Bishop Brothers Construction Company, Inc.
Proposed Minard Mine
Large Noncoal Permit Application No. 08230301
Individual NPDES Permit No. PA0270041
Response to Public Comments

Date: January 8, 2025

Figure 1 from Title 25 Chapter 211.151

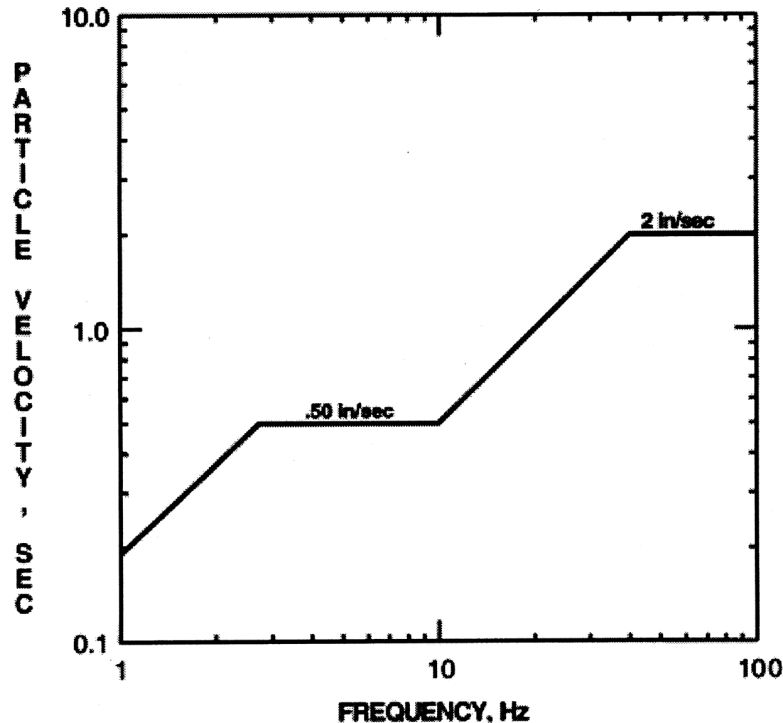
“What impact will the blasting have on any water wells in the vicinity? This is a different question than water table issues. Blast waves can travel long distances very quickly in solid ground and/or water tables. Could cased wells be cracked? How far do blast waves travel?”

The draft blast plan in Module 16 of the permit application states that the blasts will be designed to meet a scaled distance of 70. The blasting regulations in the PA Code Title

25 Chapter § 211.151 states: “Blasts shall be designed and conducted in a manner that achieves either a scaled distance of 90 at the closest building or other structure designated by the Department or meets the allowable particle velocity as indicated by Figure 1 at any building or other structure designated by the Department.”

With a scaled distance of 70, the worst case prediction for ground vibration from quarry blasting is about 0.39 in/s, which is below the lower limit for cosmetic damage to structures with finished walls (ex. cracks in plaster or drywall) at 0.5 in/sec. Given that blasting will be conducted at a higher elevation than the community to the east of the proposed mine, the vibrations in that direction would be expected to have even lower values since the reduction in elevation creates a less continuous pathway for the vibration to travel.
